INDESIT company

MTB45D2NFTK

F027289

RE0203T0 Exploded views

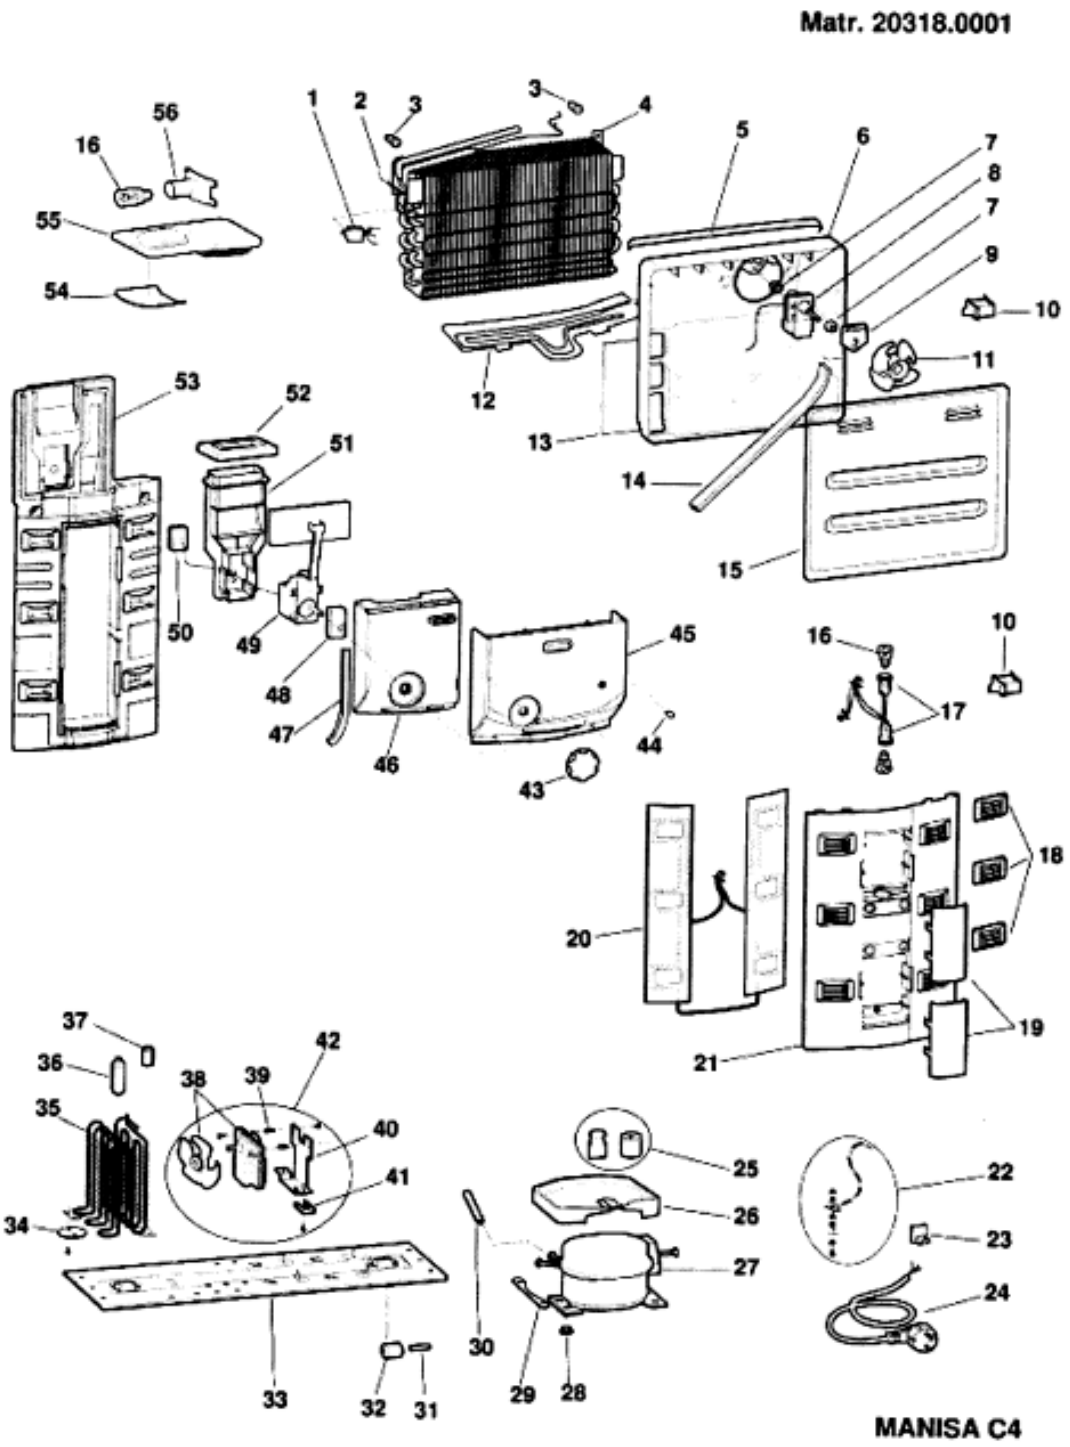
0999322: B CLASS ENERJI CONSUMPTION

Since 18/10/2002 some modifications has been done on below models to decrease energy consumption
MTB4511TK (27282)
91554- compressor TW1390YS 220/50 HIGERS
89676- compressor basement M700
89661- condenser MTA 45 V
91558- condansator DUCATI 5MF

0999323: DAMPER THERMOSTAT

Since 20.01.2003 92779 (ATEA D 1089) thermostat will be used on electronic no frost models for the turkish market and all no frost models (electr. + mech.) for europian market. Temperature in the fridge section was too high and this is the reason why new thermostat is used.

174897 - old (ATEA D 1085)
Min -1,5°C
Max -15,5°C

92779 - new (ATEA D 1089)
Min +2,0°C
Max -14,0°C

0999333: new double thermofuse

Since 05/05/2003 new double thermofuse will be used on all electronic no-frost models
old codenew code
17497192575

Since 21/11/2008 will be managed kit C00271378

RE0204T0 Exploded views

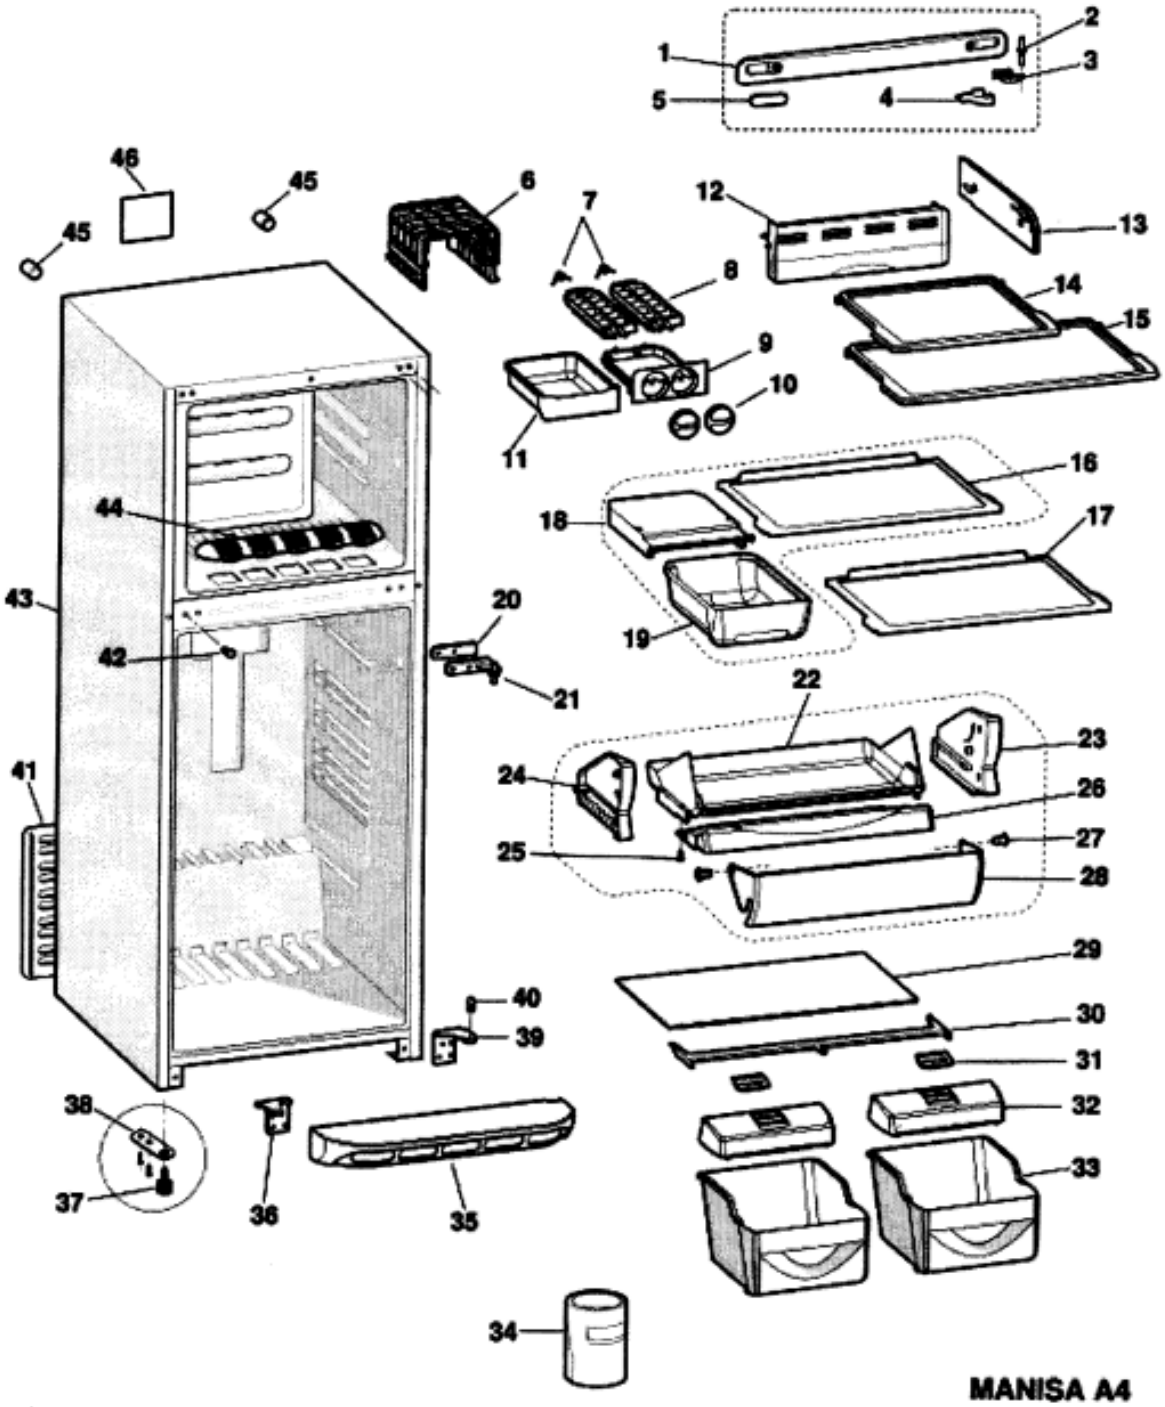
0999357: plastic compressor basement

Plastic compressor basement will be used on refrigerators since this reason adjutable foot and except single door bottom hinge have been changed. New hinge will be managed with a new code. The new bottom hinge can be used on both left and right sides.

New adjustable foot;
89682- white
89686- black

New bottom hinge assembley with adjustable foot;
110081- white
110522 - black

0999359: new metal hinge usage

A modification has been done on plastic hinges that are used on electronic Opera L70 models on 21/06/2004. New metal hinges are used instead of plastic ones. You can find below old and new part codes for reversing the door.

METAL HINGE USAGE (NEW)
172200Hinge bush 5*19.5 mm

174585Upper hinge pin

METAL UPPER HINGE (NEW)
174898metal upper hinge right / (metal)
98243metal upper hinge left / (metal)

HINGE COVER (NEW)
112229upper hinge cover right / white
112230upper hinge cover left / white
112271hinge cover left / pantone 423
112305hinge cover right / pantone 423
112009hinge cover left / inox
112011hinge cover right / inox

PLASTIC HINGE USAGE (OLD)
26353hinge bush 1mm
174959upper hinge pin

PLASTIC UPPER HINGE (OLD)
174960plastic upper hinge / right
174963plastic upper hinge / left

hinge cover (OLD)
174962hinge cover right / white
89855hinge cover / white
110525hinge cover / pantone 423
175045hinge cover left / pantone 423
175044hinge cover left / inox
89872hinge cover right / inox

RE0205T0 Exploded views

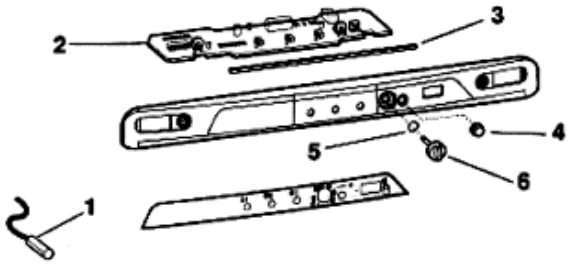
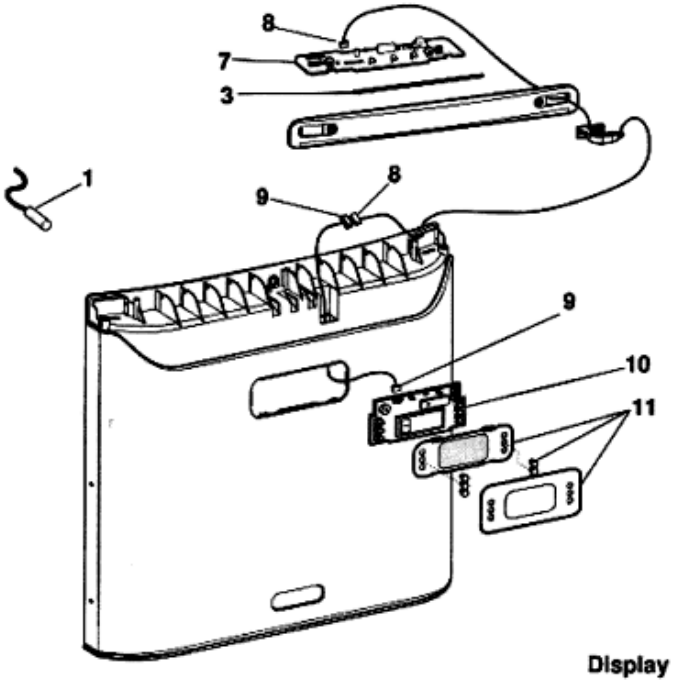
0999338: OVAL DISPLAY KNOB

Since 09-07-2003 display knob shape has been modified. Below new parst heve been used on VFD no-frost models;
White models (MT45D1 - MTB45D1)
OLD PARTS
174953 - display cover
174954 - display knob
174955 - display cover logo
NEW PARTS
95980 - display cover oval
95713 - display knob oval
95975 - display cover logo

Inox models (MT45D2 - MTB45D2)
OLD PARTS
174953 - display cover
175006 - display knob grey
89875 - display cover logo
NEW PARTS
95980 - display cover oval
95712 - display knob oval
96190 - display cover logo
